ENERGY NORTHWEST

December 30, 2002
GO2-02-198

Subject: **COLUMBIA GENERATING STATION, DOCKET NO. 50-397
REQUEST FOR AMENDMENT TO TECHNICAL SPECIFICATION
2.1.1.2, MCPR SAFETY LIMIT AND SR 3.3.1.3.2, OSCILLATION
POWER RANGE MONITOR-LPRM CALIBRATION FREQUENCY**

EVALUATION: REQUEST FOR AMENDMENT TO TECHNICAL SPECIFICATION 2.1.1.2 AND SR 3.3.1.3.2

Figure A.1 Columbia Generating Station Cycle 17
Radial Power Distribution for SLMCPR Determination

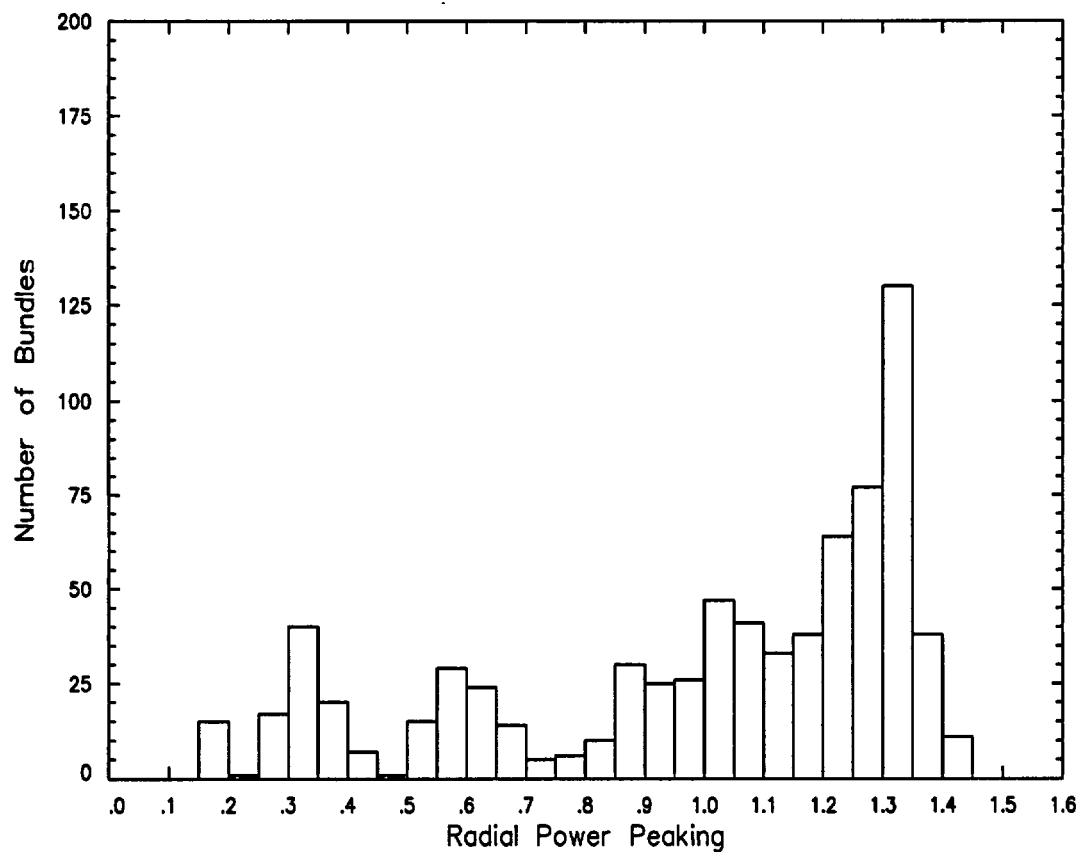
exposure in the design step through. The safety limit radial power histogram for the limiting cycle exposure of 6000 MWd/MTU (i.e., the exposure that results in the highest number of rods expected to experience boiling transition) is presented in Figure A.1. Results for single-loop operation (SLO) are also presented in Table A.2 and support a MCPR safety limit of 1.10.
